25241-01-002

**PROPOSED DEVELOPMENT AT
DARNDALE, PRIORSWOOD, CO. DUBLIN**

Road Safety Audit Stage 1

Figure 2.1 – No signage to control traffic at junction on one way street going north

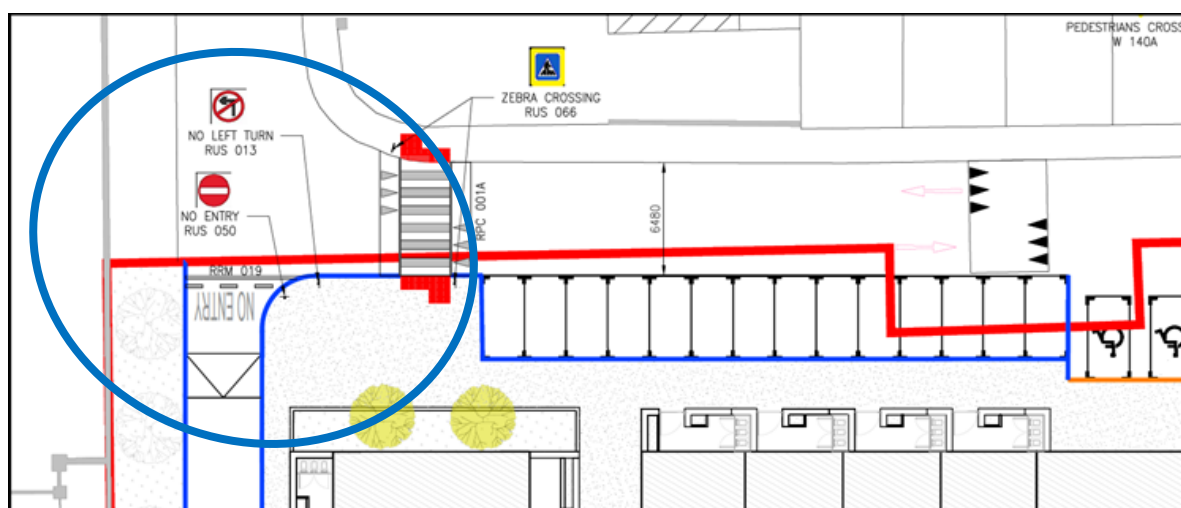
There does not appear to be any traffic control devices in place at this junction for traffic going north from the one way street, shown in Figure 2.1 below.

The road coming from the bottom of the drawing is a one way street going north, with No Entry signs in place for traffic going south on the main road.

However, there does not appear to be any signs or road markings in place to instruct motorists on the one way street to yield or stop for the main road. This lack of signage could lead to confusion, risk taking and collisions resulting in injuries.

Recommendation: Provide YIELD signage/road markings for traffic going north at this junction.

2.1	Yes	Yes	-----	-----
2.2	No	No	The number of parking spaces provided exceeds the minimum requirements set out by Dublin City Council Development Plan standards. The proposed layout has been carefully assessed to balance parking provision and road safety considerations.	Yes

Figure 2.2 – Location of parking spaces

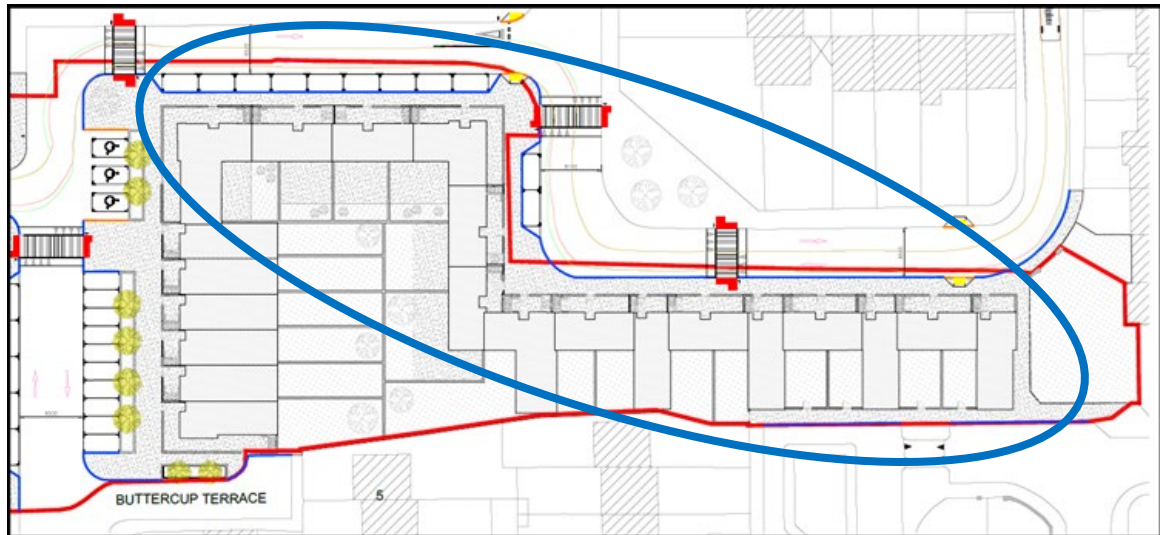
The location of some of the parking spaces seems to be some distance from quite a number of the dwellings. In addition, it is unclear if sufficient car parking spaces are provided within the proposed development. If sufficient car parking spaces are not provided it may lead to residents parking on the streets or footpaths, blocking entrances and blocking other cars, leading to risk taking collisions and injuries.

Recommendation: Ensure that sufficient parking spaces are provided within the proposed development located in close proximity to all dwelling units.

Figure 2.3 – Inadequate Intervisibility

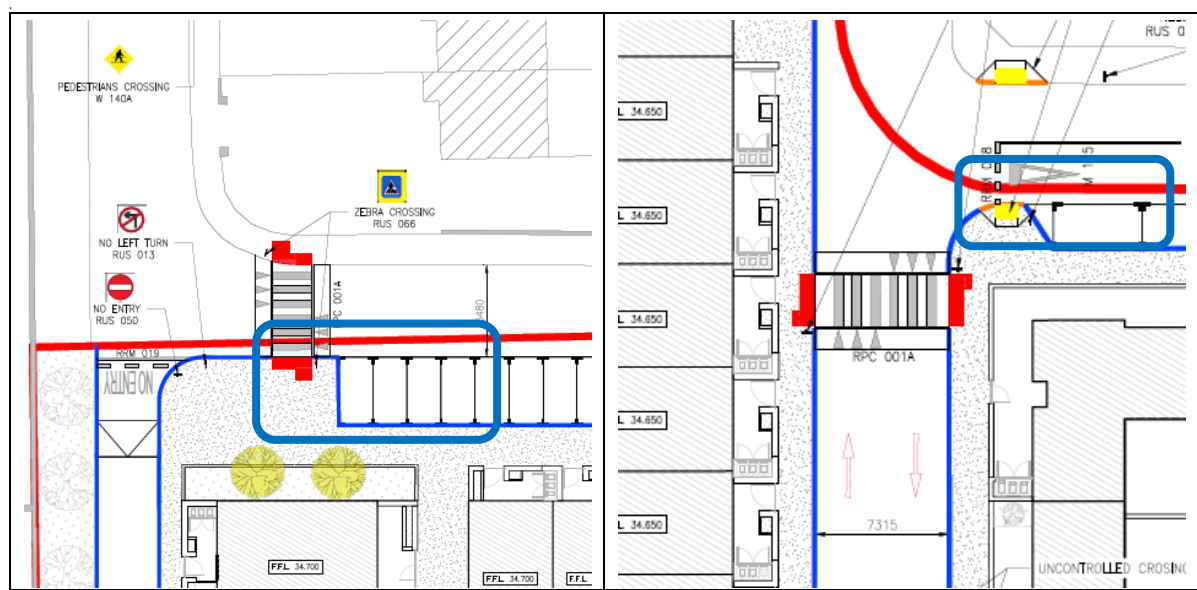
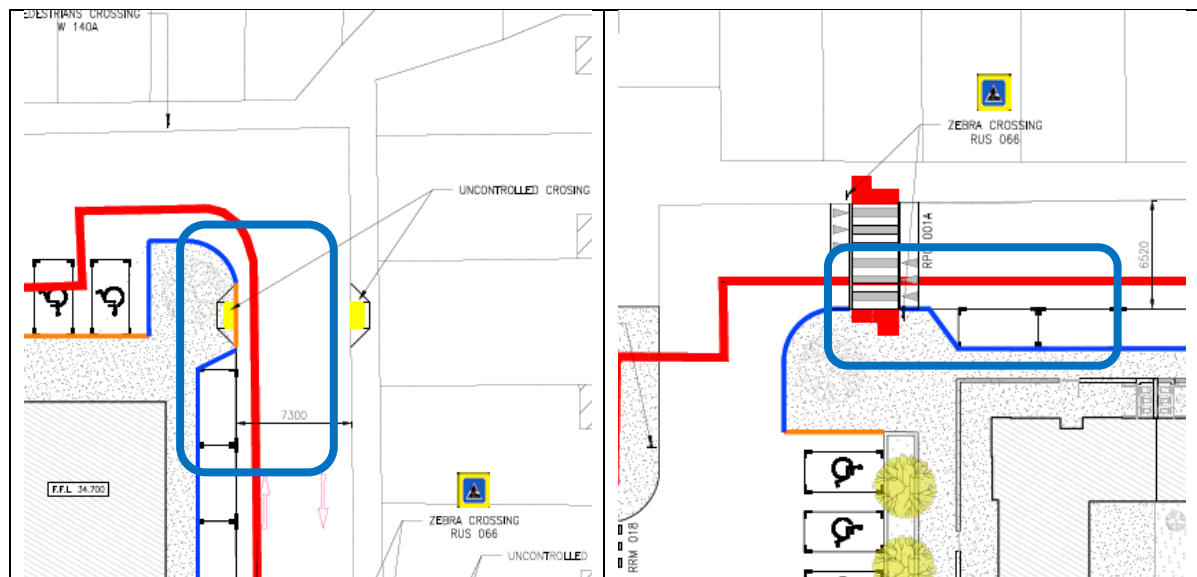
Intervisibility between pedestrians crossing pedestrian crossings at the locations including but not limited to those shown below and drivers of vehicles approaching the crossings may be restricted by parked cars. A lack of adequate intervisibility may contribute to a collision at these locations.

Recommendation: Ensure that adequate intervisibility is provided between pedestrians and drivers of vehicles approaching all pedestrian crossing locations.

2.3	Yes	Yes	Note: The majority of the proposed zebra crossings have been revised to uncontrolled crossings in response to the audit comments. Additionally, obstructing parking spaces adjacent to crossing points have been removed to ensure adequate pedestrian visibility and restore compliant sightlines.	-----

Figure 2.4 – Pedestrian Desire Lines Not Served

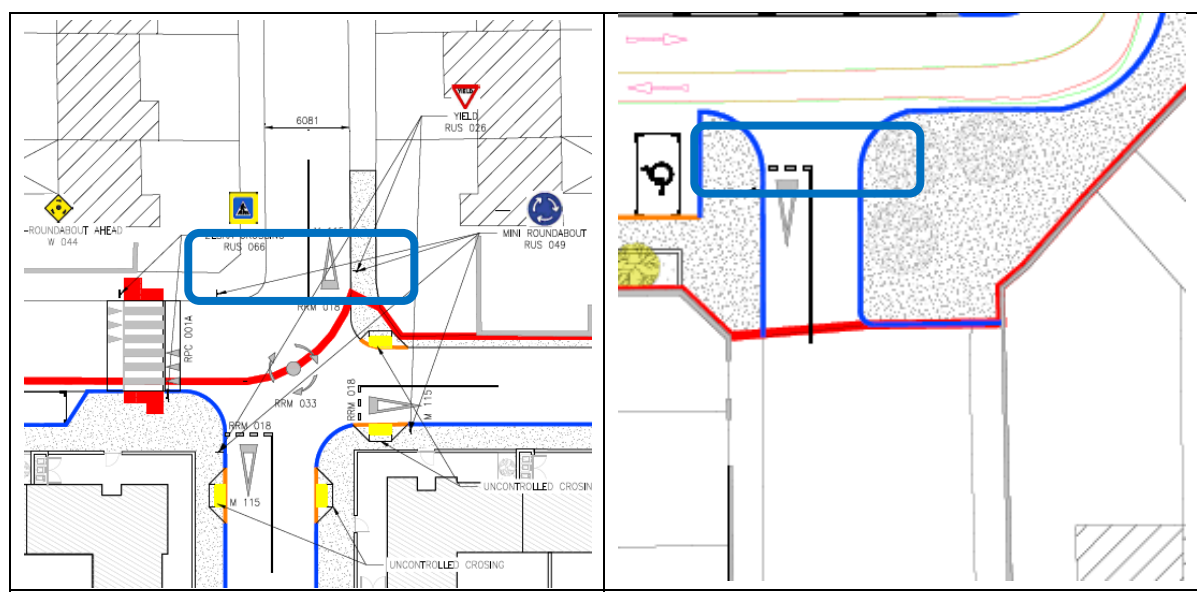
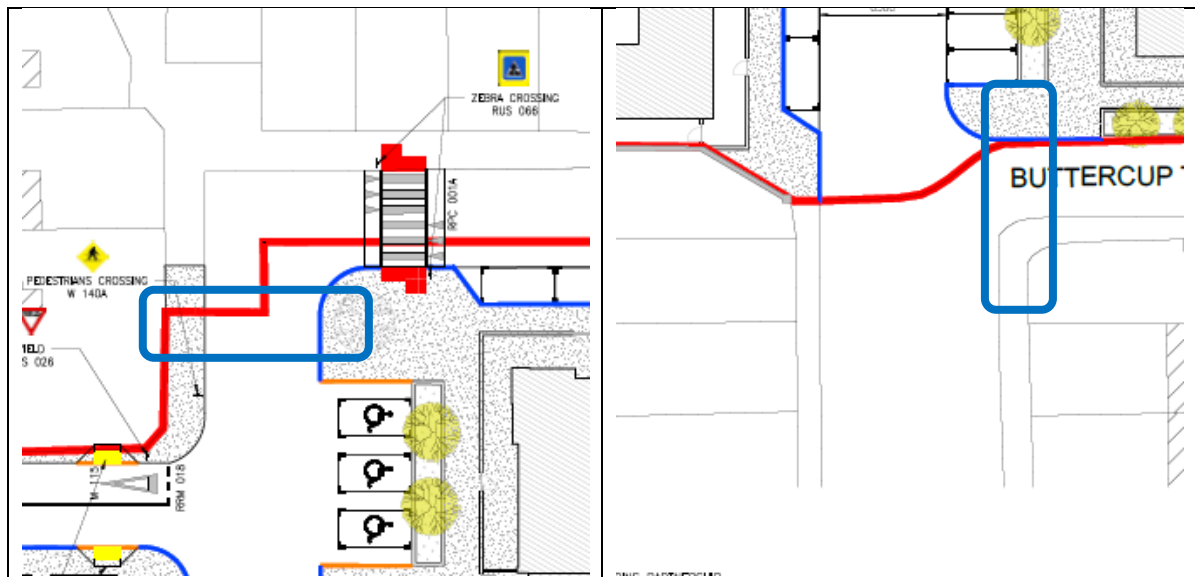
Connectivity of pedestrian facilities appears incomplete in terms of provision of pedestrian crossings at the locations including but not limited to locations shown below. The absence of pedestrian crossings along desire lines may lead to pedestrians crossing at an unsafe location, increasing the risk of collisions with vehicles.

Recommendation: Adequate pedestrian crossings should be provided within the development to cater for the desire lines of pedestrians.

2.4	Yes	Yes	-----	-----
2.5	Yes	Yes	-----	-----
2.6	Yes	No	The previously proposed mini-roundabout at the junction has been removed from the design.	Yes
2.7	Yes	Yes	Note: A small number of new road signs are proposed along an existing footpath. Due to spatial constraints within the existing corridor, a localised reduction in footpath width occurs at these locations. However, the clear unobstructed width is	-----

Figure 2.5 – Inadequate Footpath Width

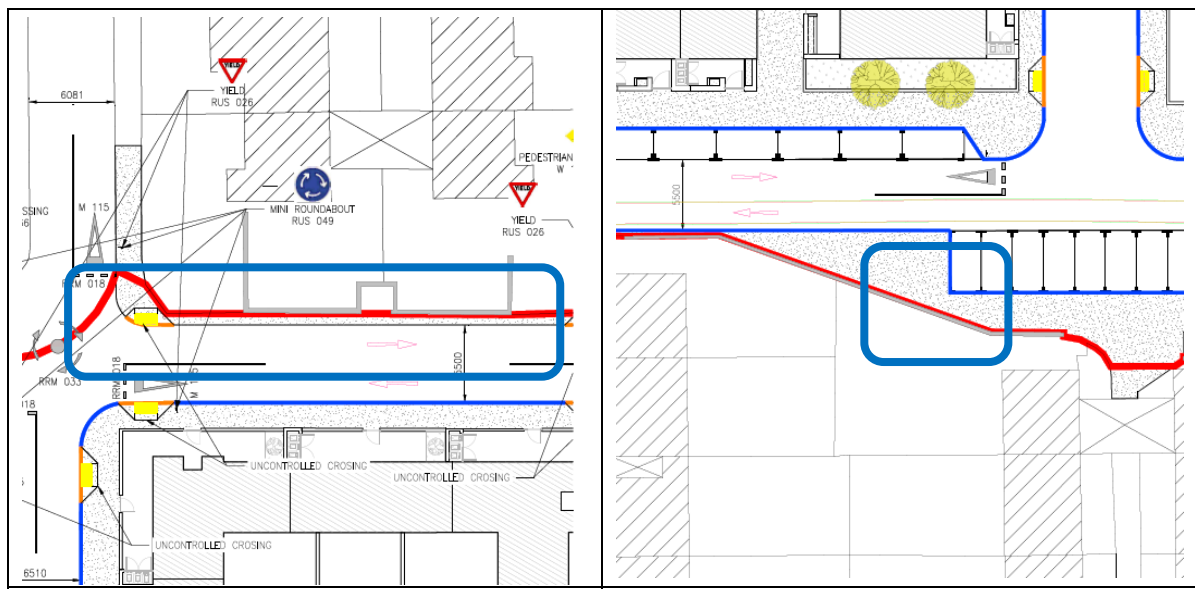
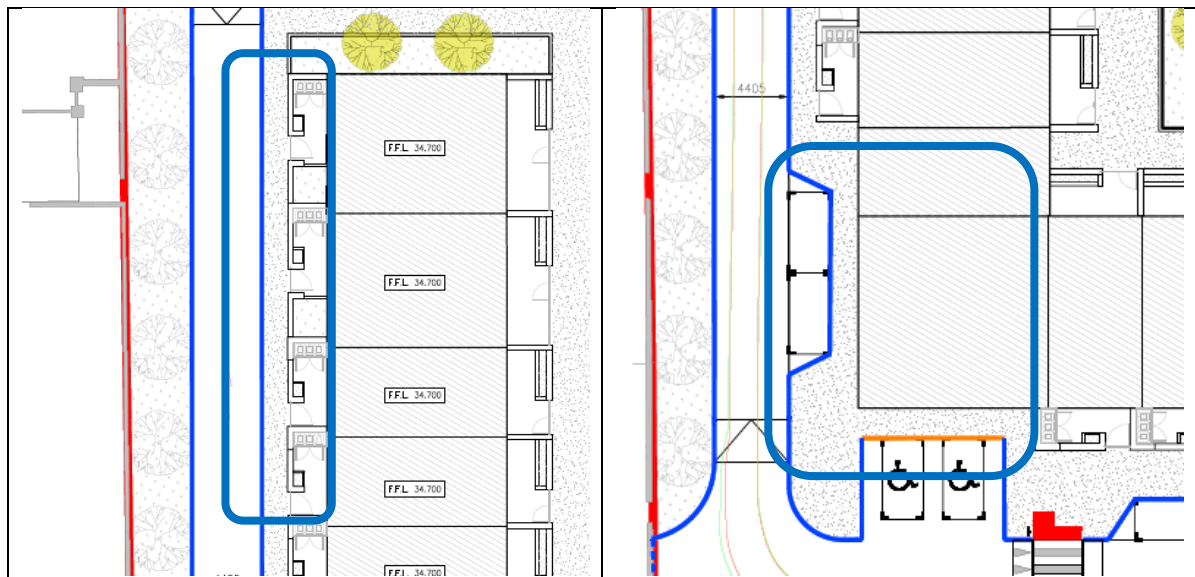
The footpath within the development appears to be narrow at multiple locations including but not limited to those shown on the images below. Mobility impaired pedestrians may not have sufficient room to safely manoeuvre along the path.

Recommendation: Provide an adequate footpath width in accordance with the DMURS.

Figure 2.6 – No Yield Sign or markings

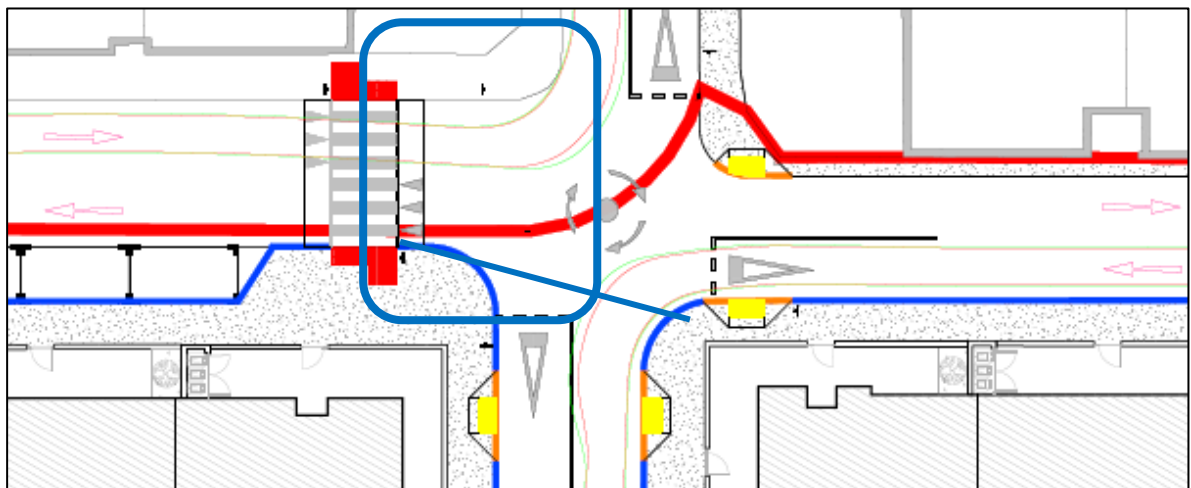
Traffic control at the roundabout entry on the western arm appears incomplete due to the absence of a yield sign or road marking. The lack of clear yield control may lead to driver uncertainty regarding right-of-way, increasing the risk of vehicle conflicts with circulating traffic.

Recommendation: Ensure standard yield signage and road markings are provided at the roundabout to clearly define right-of-way and reduce the risk of vehicle conflicts.

Figure 2.7 – Footpath Width Compromised by Street Furniture

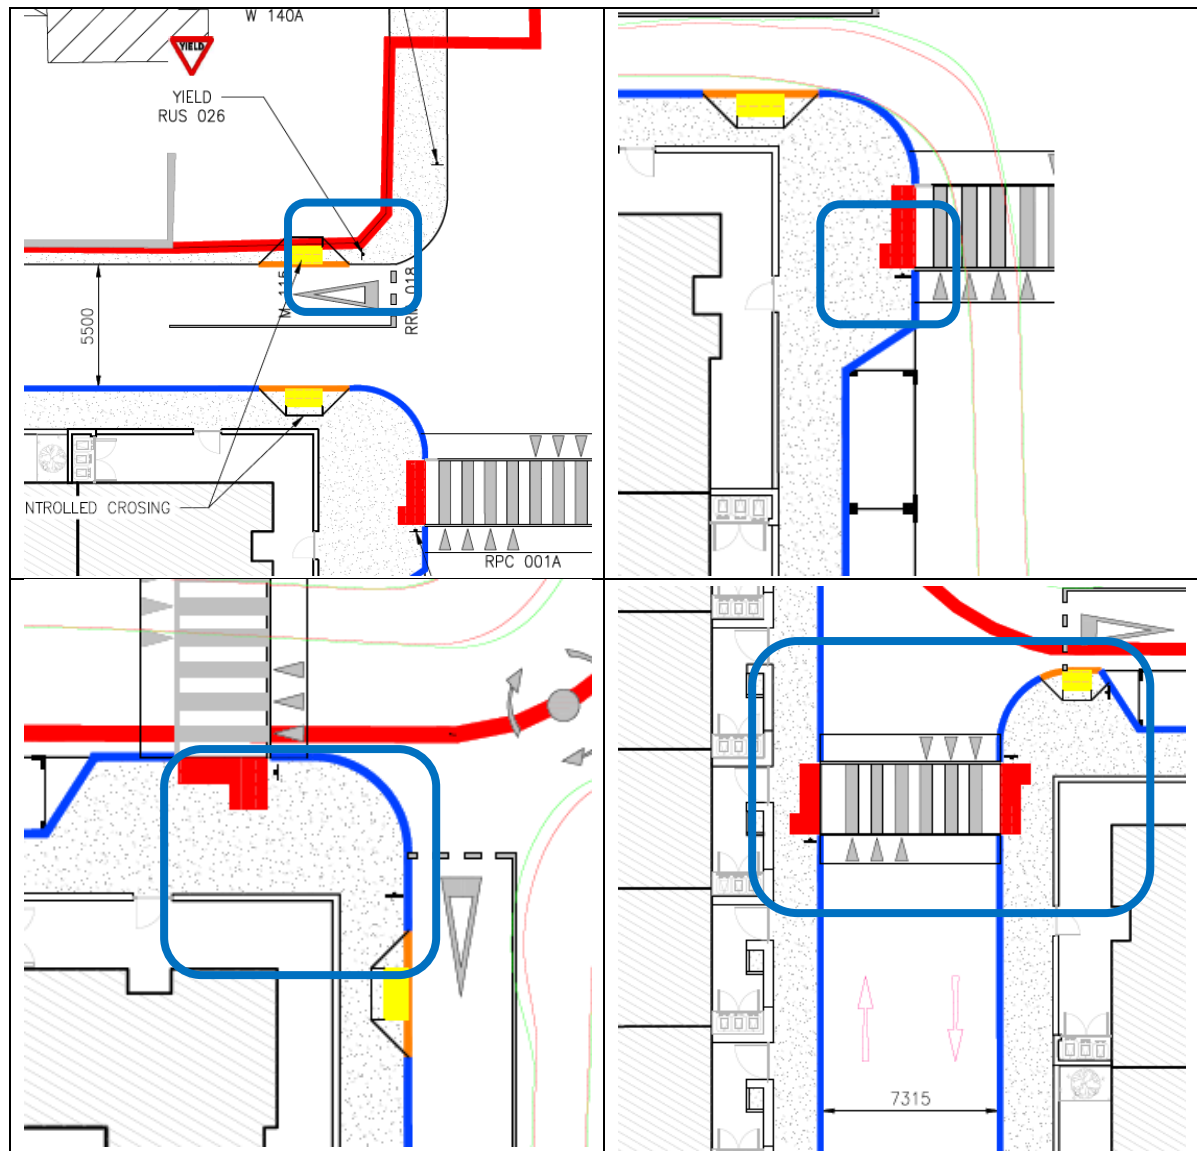
Road signs are indicated to be located within the footpath at a number of locations including but not limited to those shown on the images below. Road signs located within footpaths may restricted the effective footpath width. A lack of appropriate footpath width may force mobility impaired pedestrians onto the road, where they would be at an increased risk of being struck by a passing vehicle.

Recommendation: All street furniture should be located such that they do not obstruct the footpaths.

maintained at not less than 1500mm at the most constrained point.	
2.8	Yes	Yes	Visibility splays have been reviewed and verified in accordance with DMURS requirements. Trees will be pruned to achieve a minimum clear stem height of 2.0m, ensuring unobstructed junction sight distances.	-----

Figure 2.8 – Inadequate Junction Intervisibility

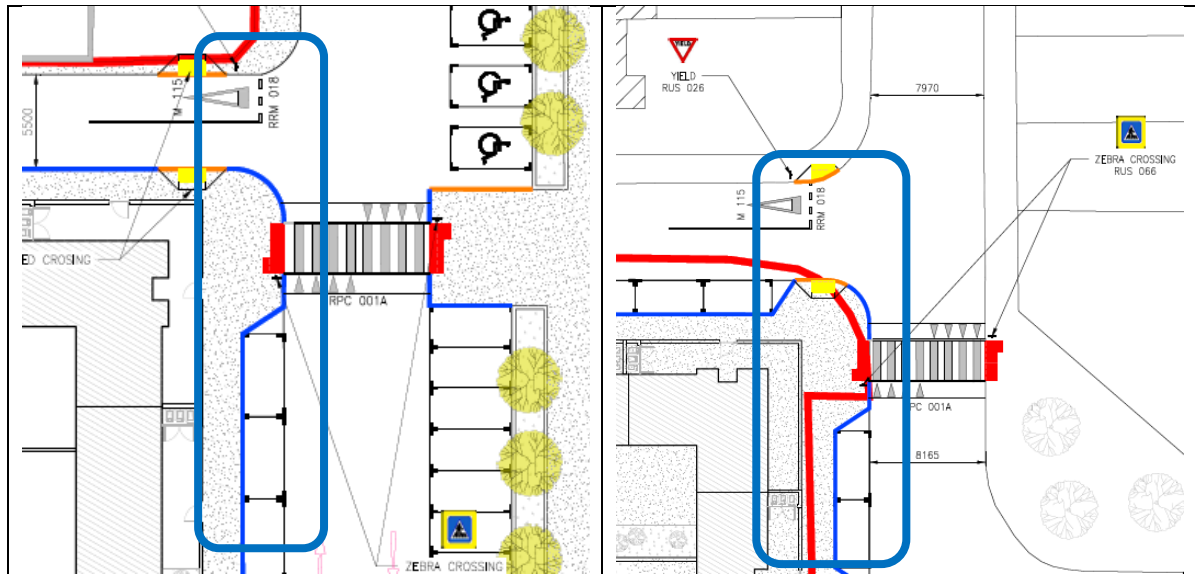
Stopping sight distance and intervisibility at multiple junctions within the development including but not limited to those shown on the images below may be restricted by a tree and parked vehicles on the inside of one of the bends. A lack of appropriate stopping sight distance may contribute to a collision at this location.

Recommendation: Ensure adequate sight distance and intervisibility are maintained at all junctions. If needed, obstructive vegetation and on-street parking, particularly on the inside of bends, may be removed.
